ADDENDUM NO. 1

JOHN STREET PARK SITE IMPROVEMENTS 2025 - CONSTRUCTION PHASE

BID #25-037

ISSUED: October 9, 2025

Layout
Plan

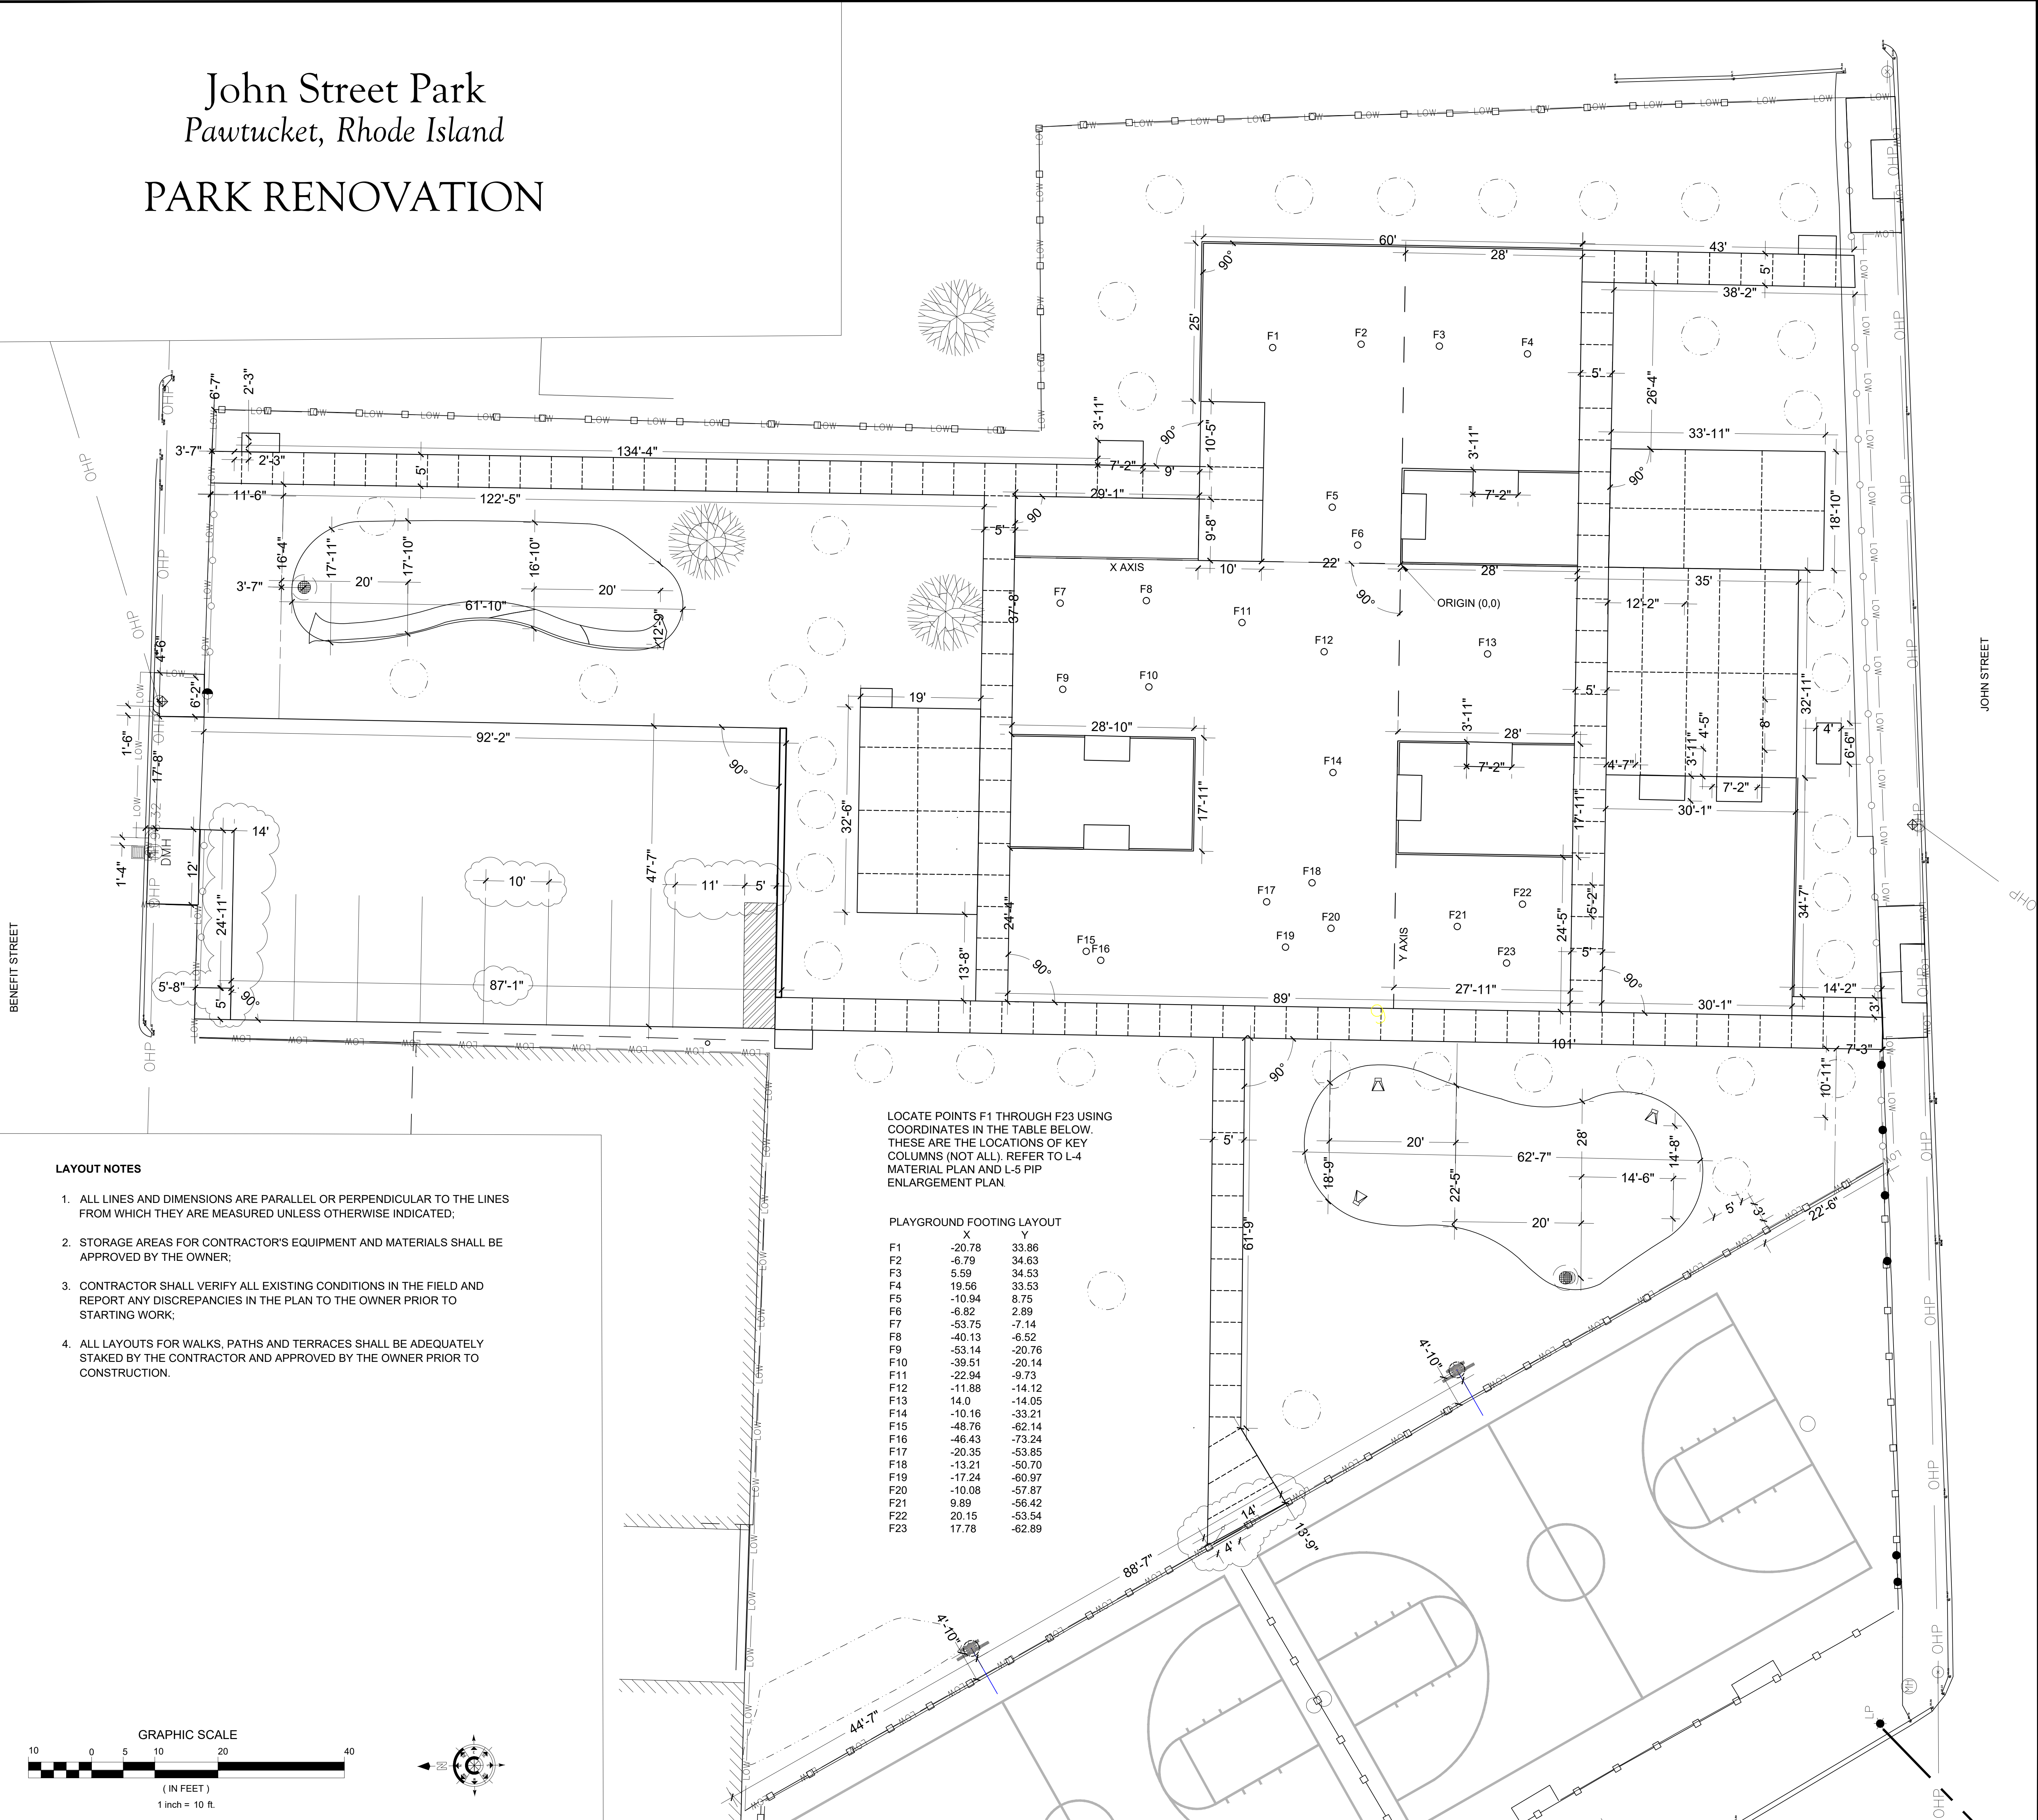
Q6: *Is there a gate opening at the basketball courts?*

A6: Yes, Gate detail will be issued under Addendum No. 2. See revised plans attached to this addendum for location.

L-6

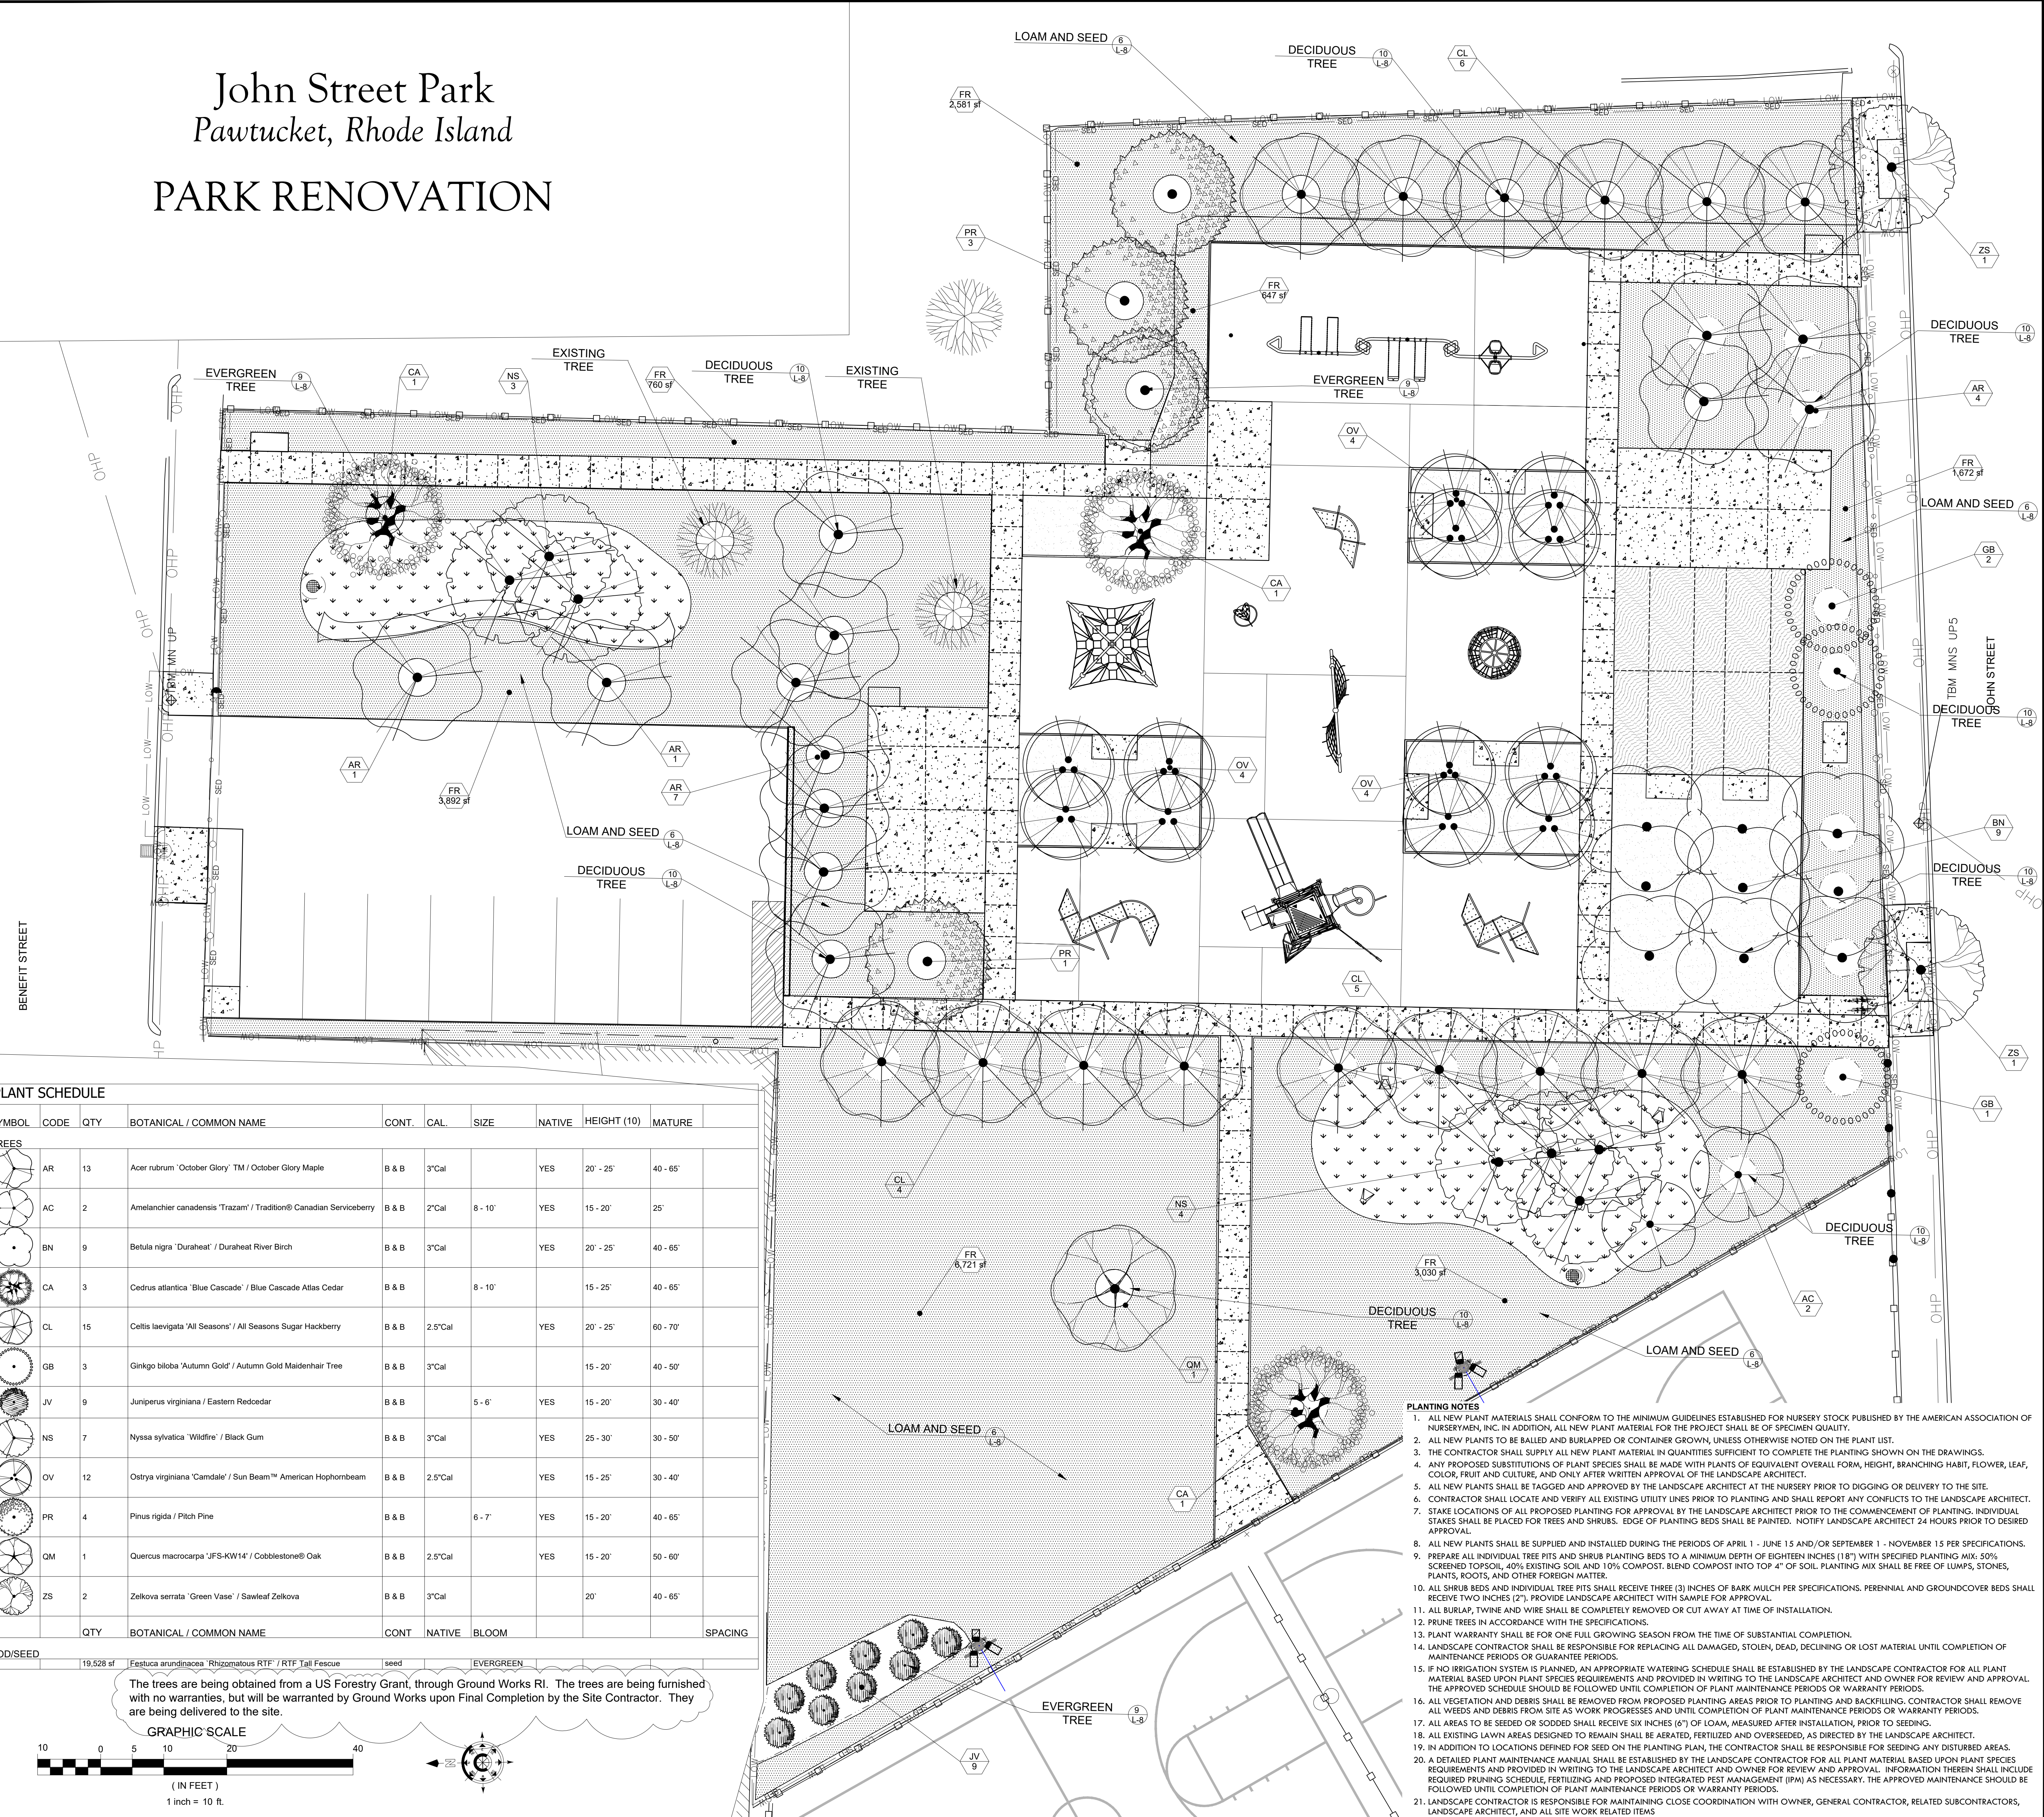
Q5: Will the trees be delivered to the site or will the site contractor be responsible for delivery?

A5: The tree supplier will deliver to the site. Coordination of delivery will be done by the site contractor and tree supplier. See also revised note on L-6, attached to this addendum.

The trees are being obtained from a US Forestry Grant, through Ground Works RI. The trees are being furnished with no warranties, but will be warranted by Ground Works upon Final Completion by the Site Contractor. They are being delivered to the site.
